NO: CON-025 PRODUCT: XS5 and XS2 Sensor I/O Connectors

DATE: June 2010 TYPE: Product Modification

## Sensor I/O Connector: Product Label Change

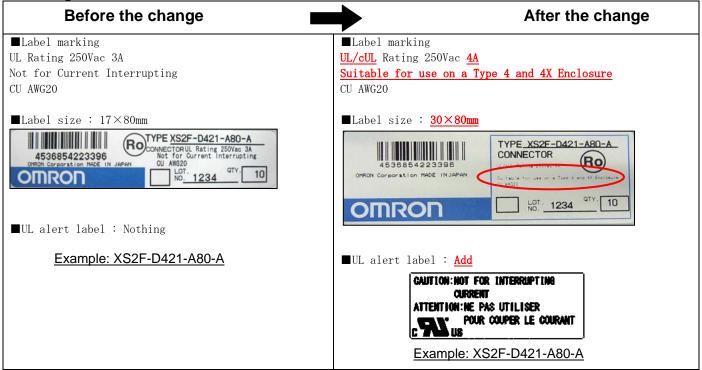
1.- Add marking "Suitable for use on a Type 4 and 4X Enclosure" on the label.

2.- Change label size. (Applicable Model: All above models)

3.- Add UL alert label. Change rating from 3A to 4A.
